OSA -2871-65.

1 July 1965

RED KNOB MODIFICATIONS

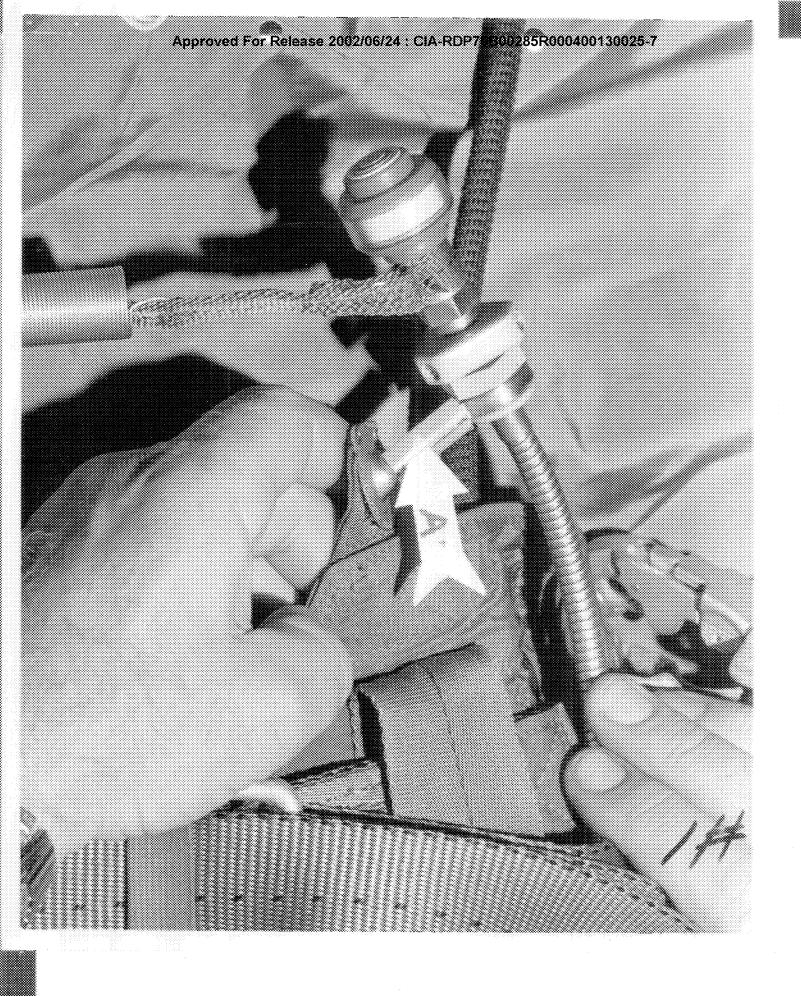
The swivel "A" in Photo #1 has been removed and the housing and fitting hand sewn as in Photo #2. We used five turns of waxed five cord cotton at "A" and two turns in each of the two corrugations at "B" in Photo #2. This was done to get the "Red Knob" to hug the pilot closer. It stood out too far before and was yulnerable to catching on the arms.

We are adjusting the retention to eight to twelve pounds vs. the previous six to ten pounds and sealing the screws with "Locktite".

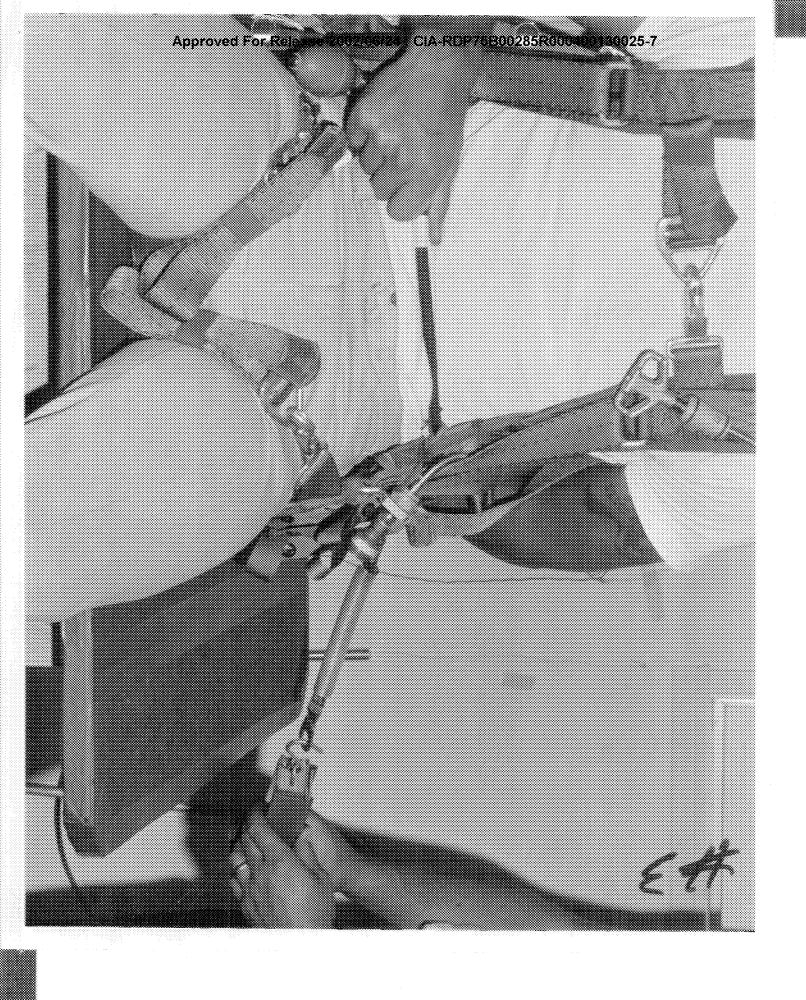
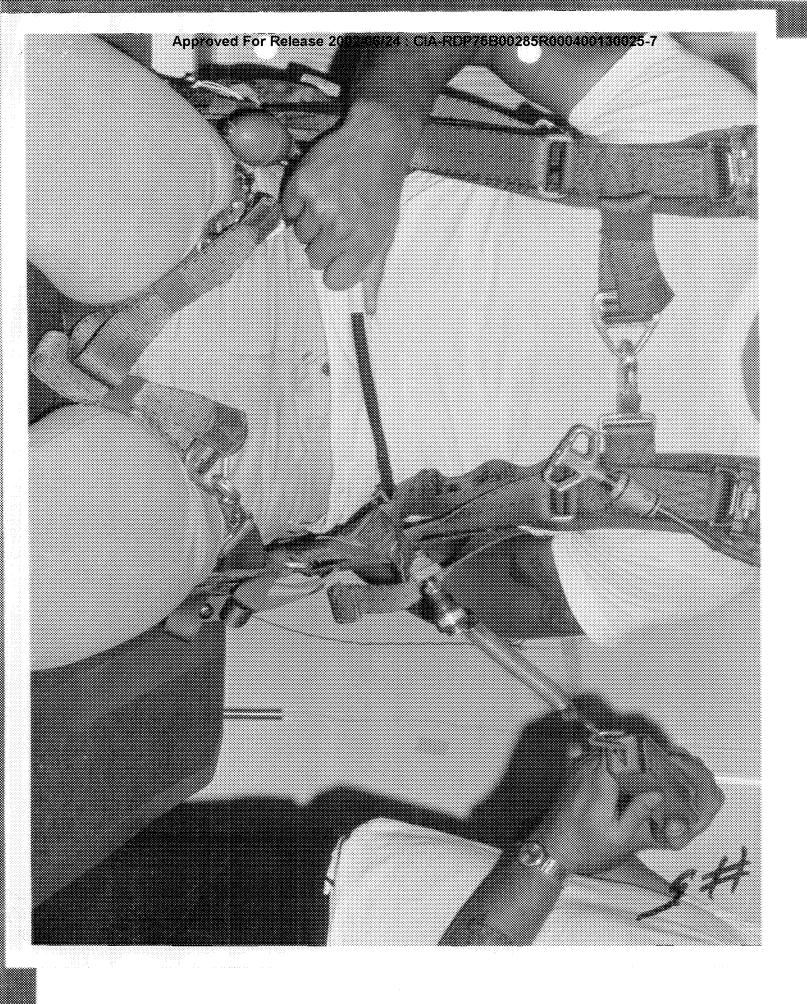
After the changes were made, we checked the extraction forces at different angles of pull as shown in Photos #3, #4, #5 and #6. Extraction forces were, nine, ten, twelve and nine pounds respectively.
